ADDENDUM C

NORTH PARK MINI PARK

BID NO.:	<u>K-20-1864-DBB-3</u>
SAP NO. (WBS/IO/CC):	<u>S-10050</u>
CLIENT DEPARTMENT:	<u>1714</u>
COUNCIL DISTRICT:	<u>3</u>
PROJECT TYPE:	<u>GC</u>

ENCLOSURE: PLAN

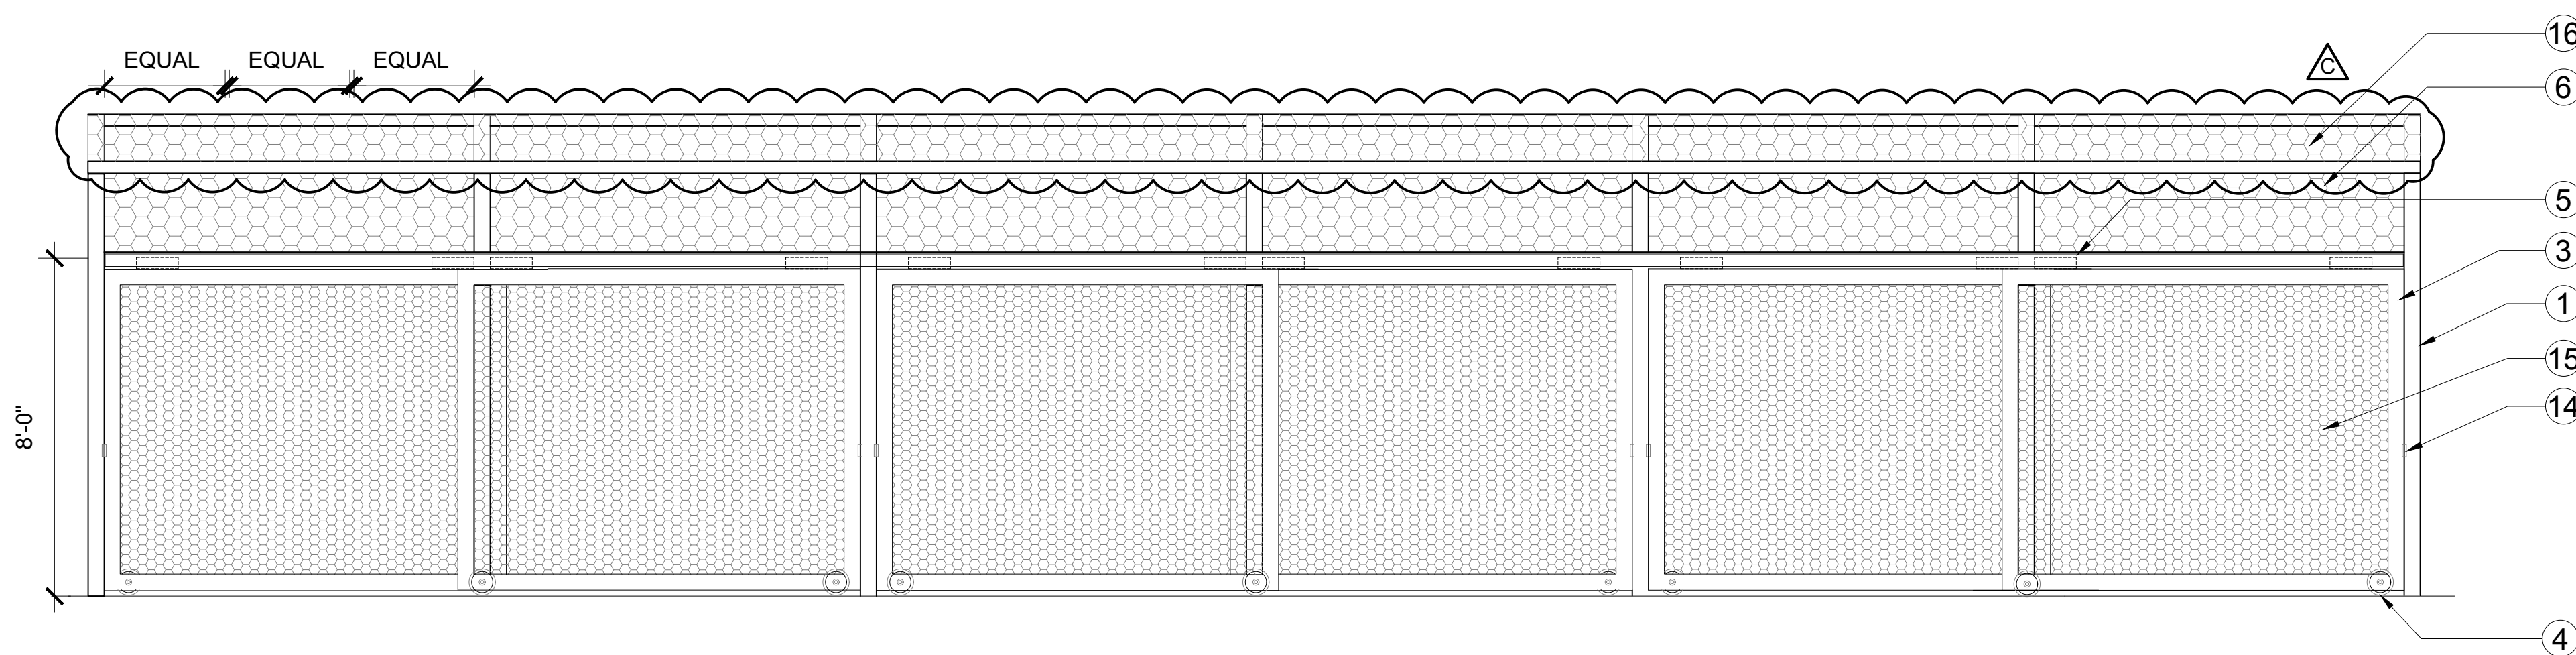
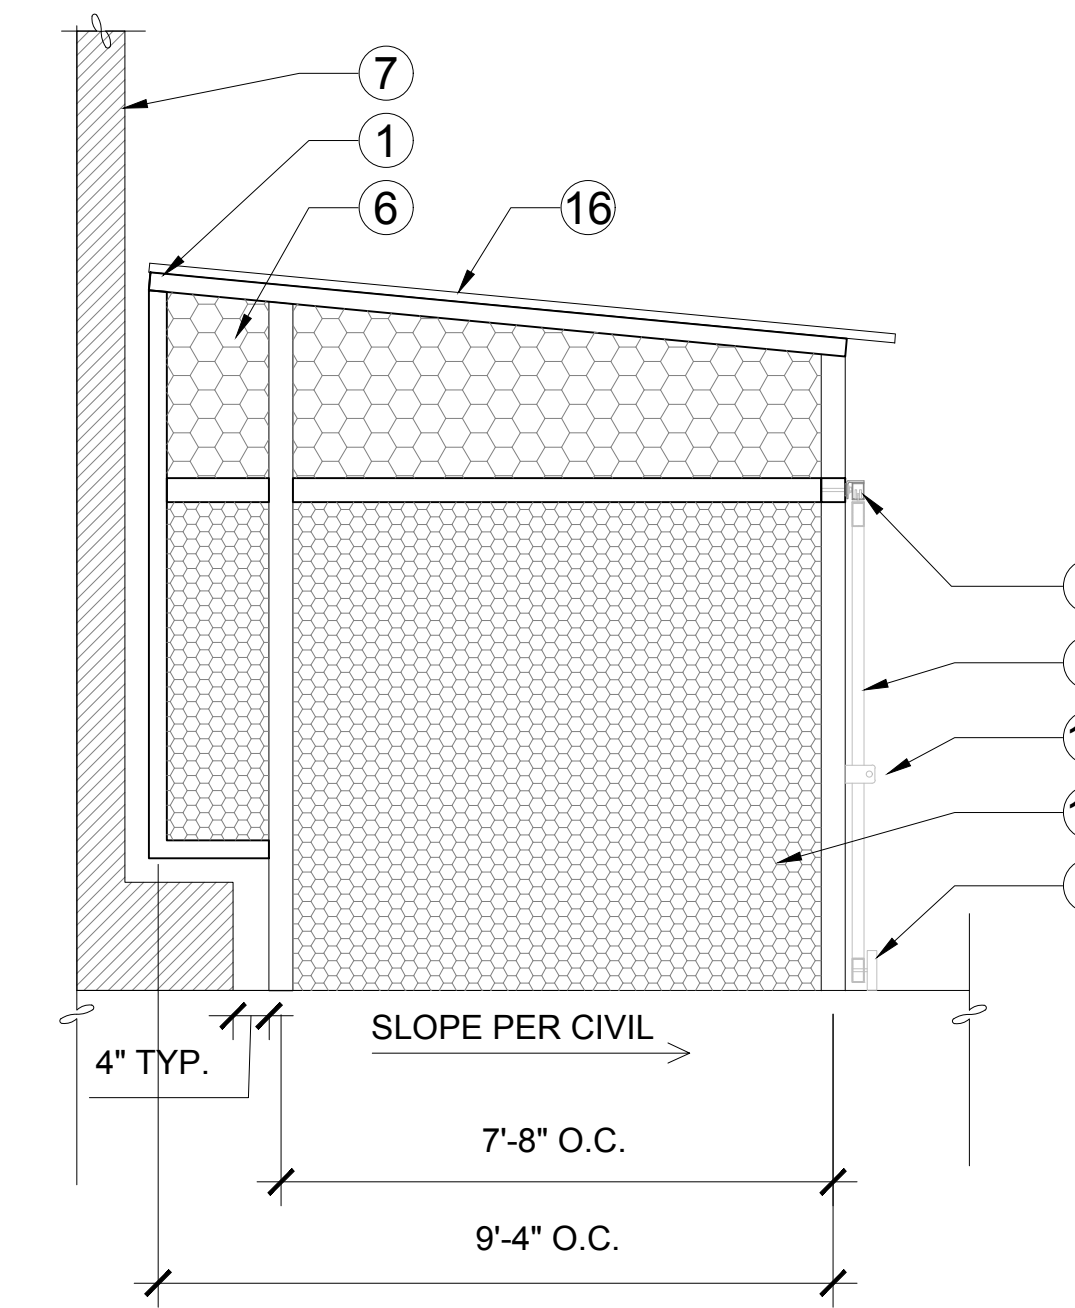
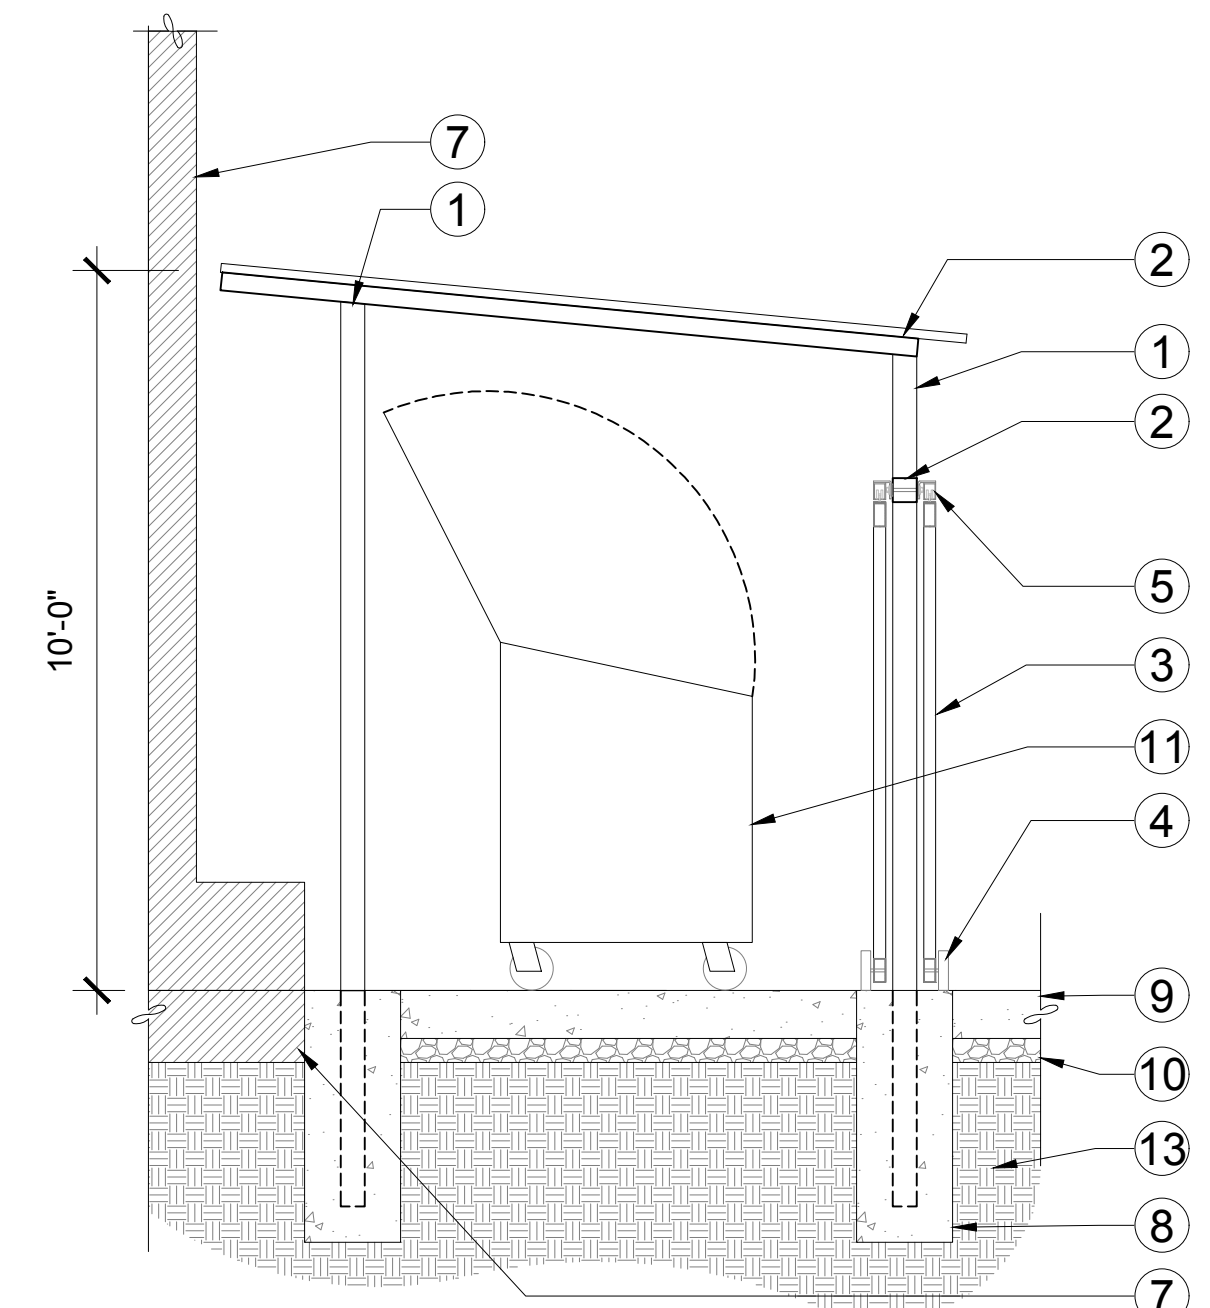
DETAIL REVISED. ROOF CHANGED TO PERFORATED.

ROOF PLAN

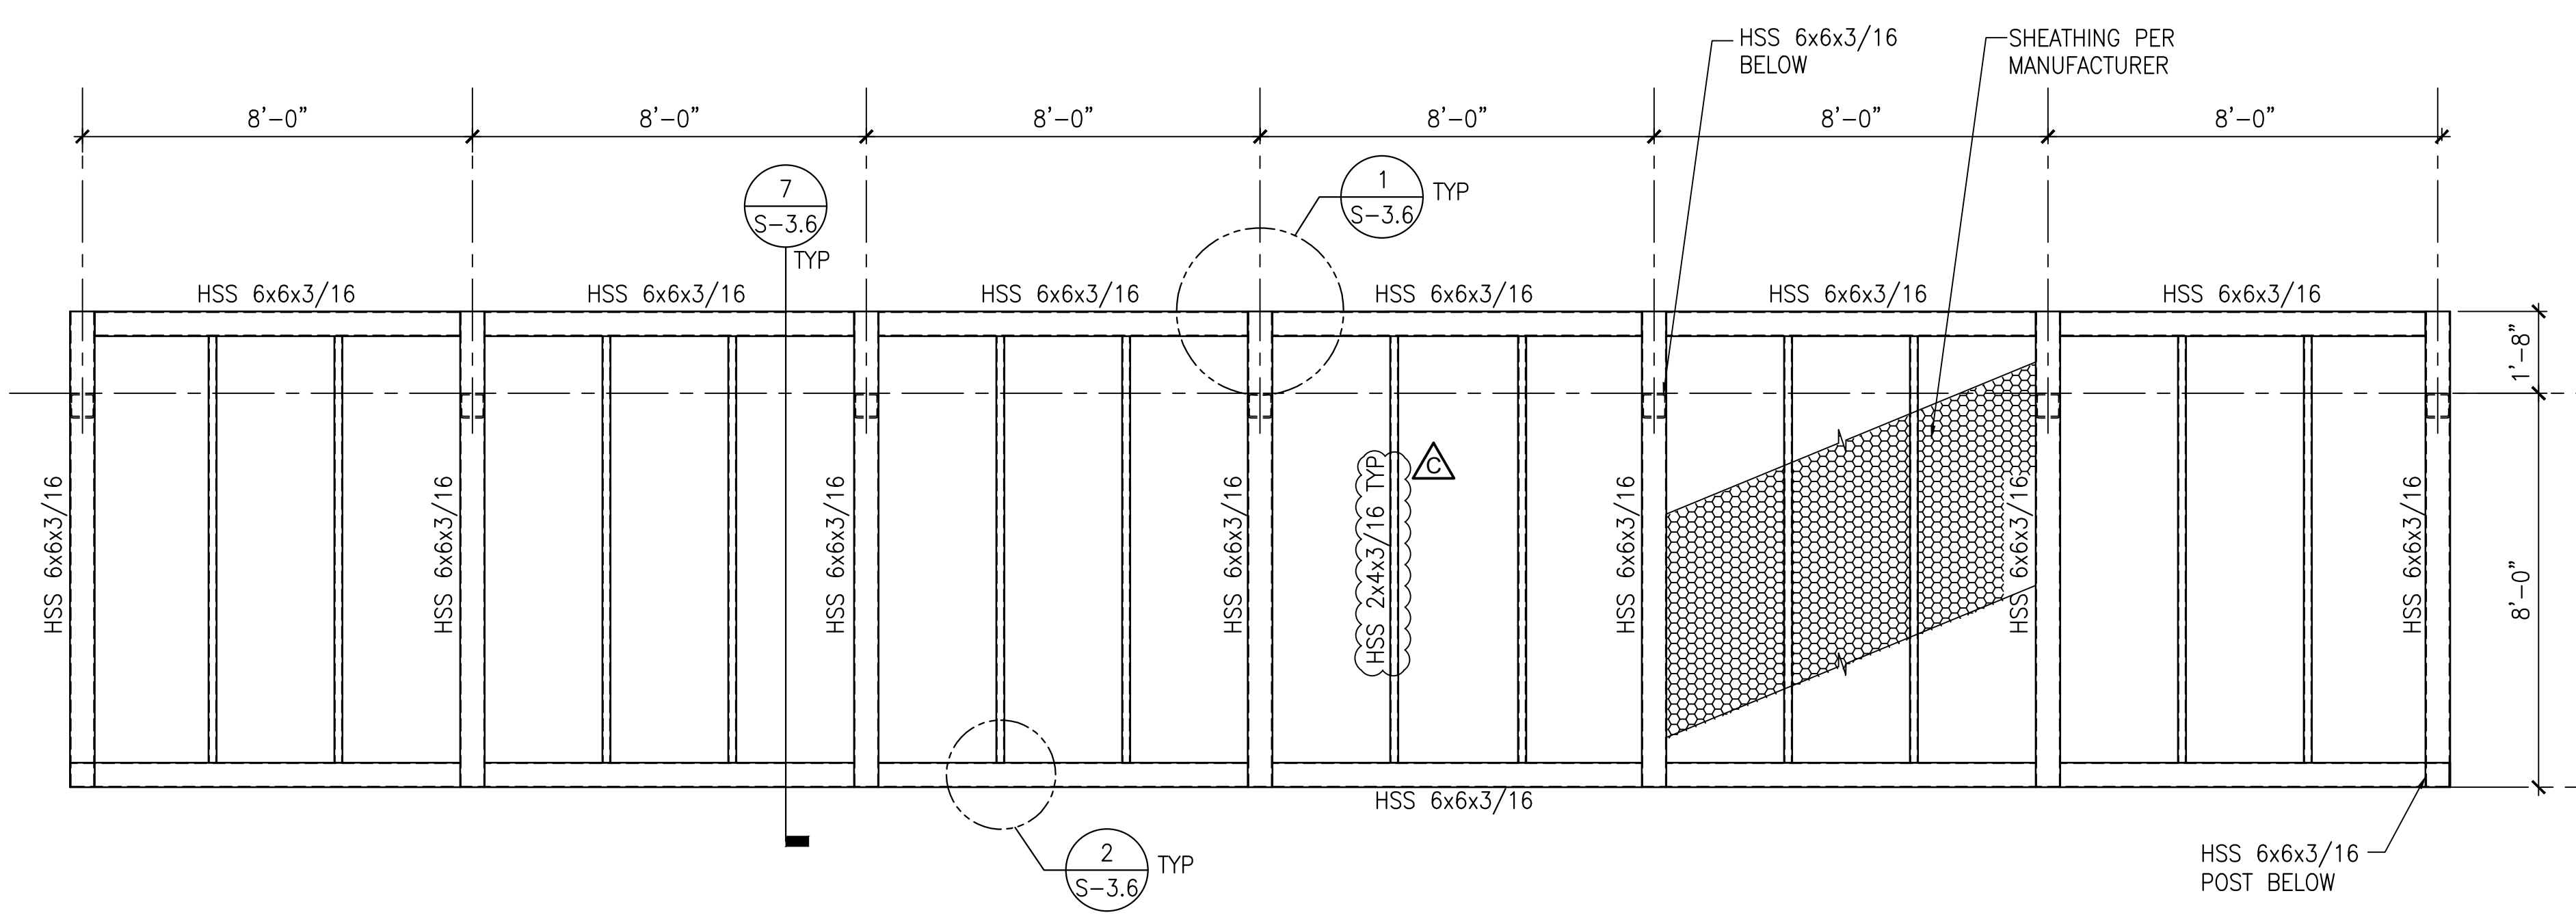
CHANGES TO NOTES.

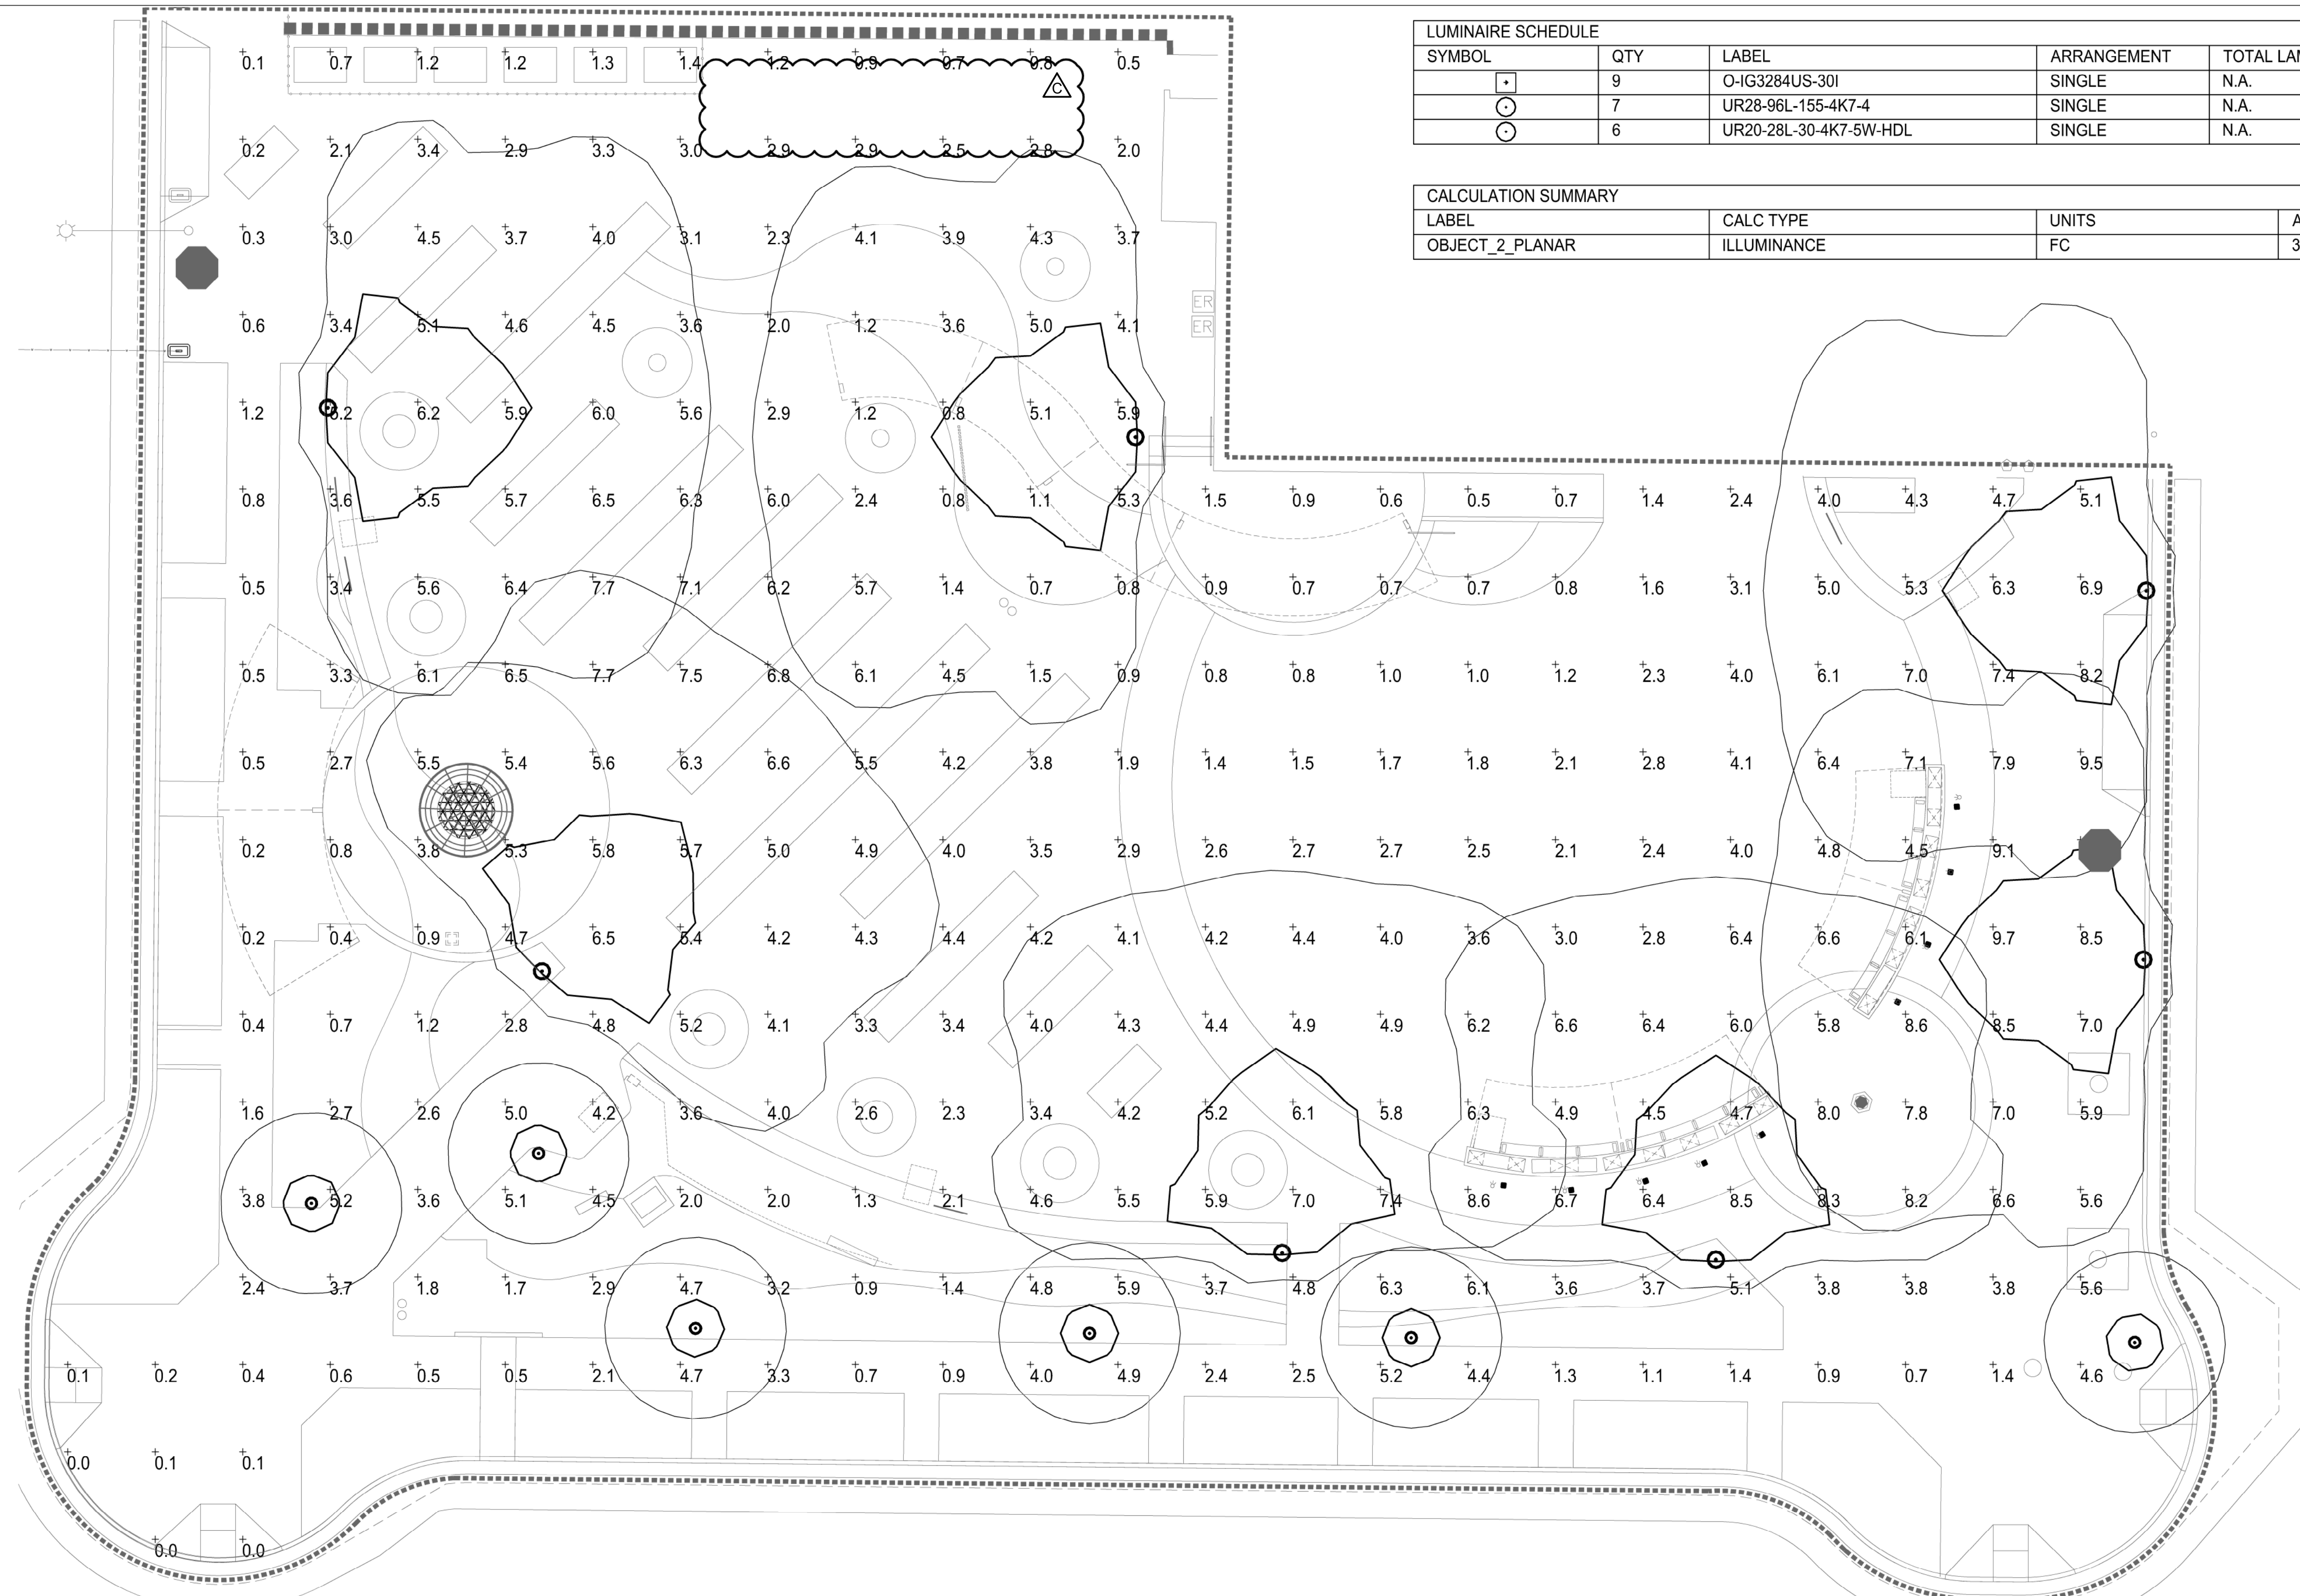
CHANGES TO PLAN AND LEGEND. SUMP PUMP ADDED. STORAGE CONTAINER REMOVED.
